STAFF REPORT
COMMUNITY DEVELOPMENT DEPARTMENT

DATE: 3/9/2021
 TO: Mayor & City Council
 FROM: Joseph Dodson, Associate Planner
 208-884-5533
 SUBJECT: FP-2021-0005
 Sagewood West Final Plat

A Final Plat consisting of 53 detached single-family building lots and 7 common lots on 10.37 acres of land in the R-8 zoning district. *Entire Sagewood West subdivision is proposed in this final plat; there should not be any future final plats for this project.*

D. Common Drive Exhibit

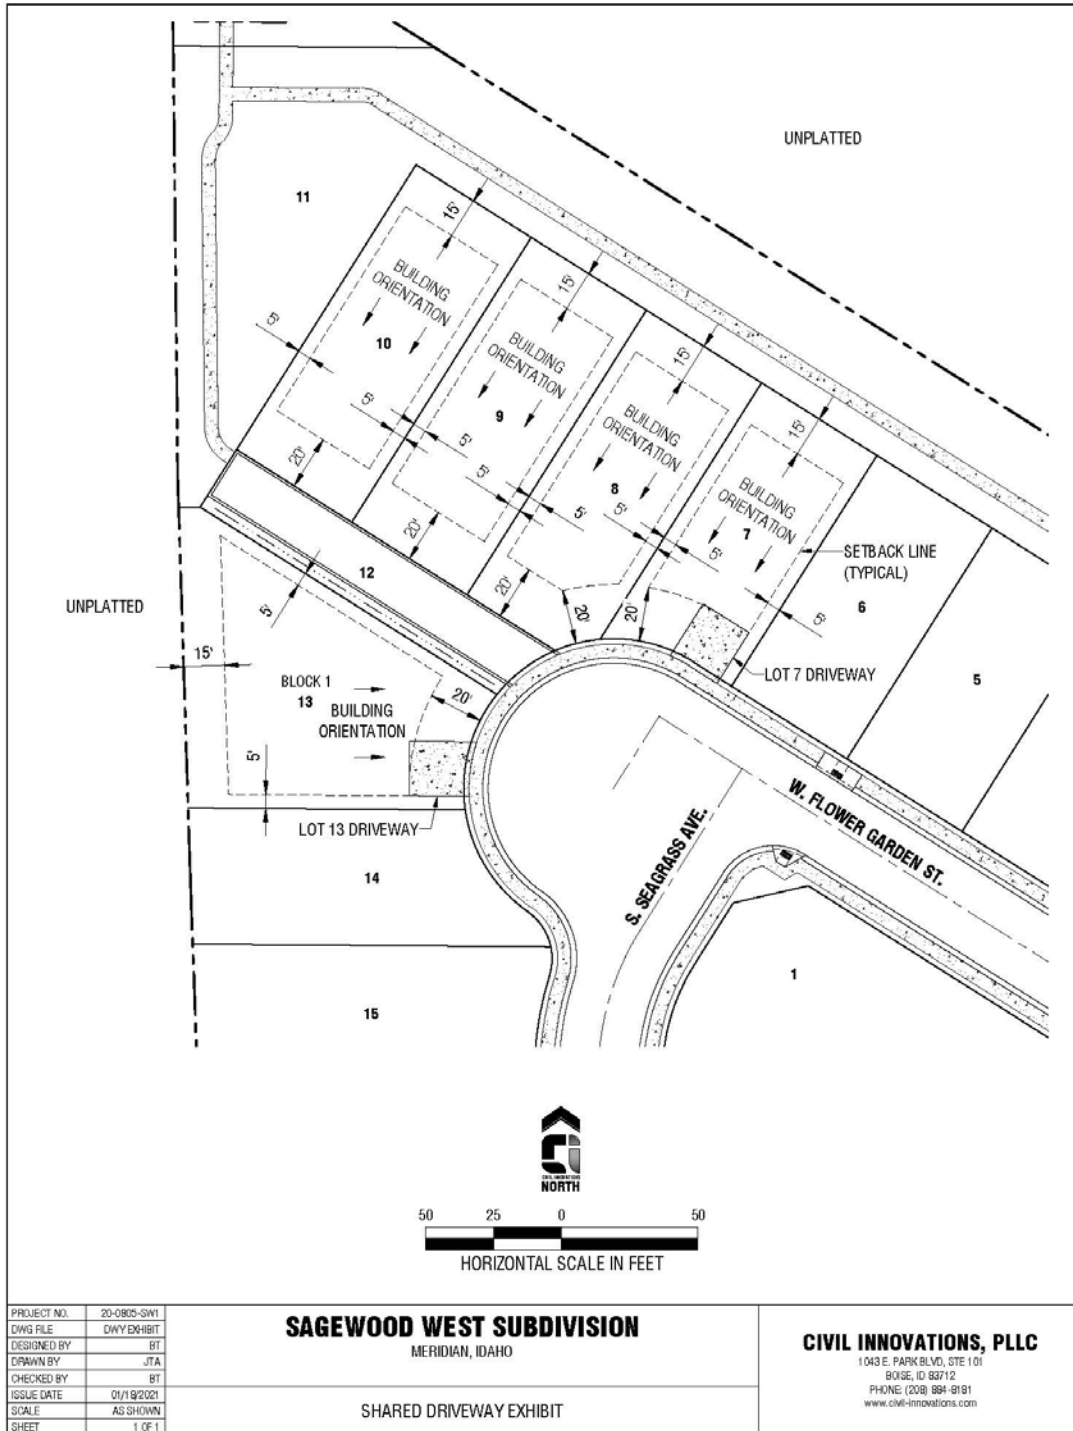
5. The landscape plan prepared by Jensen Belts Associates (Exhibit C), dated February 26, 2021, is approved as submitted:
6. Prior to signature on the final plat by the City Engineer, the Applicant shall revise the common drive exhibit (Exhibit D) to match the revisions shown on the revised landscape plan (Exhibit C).
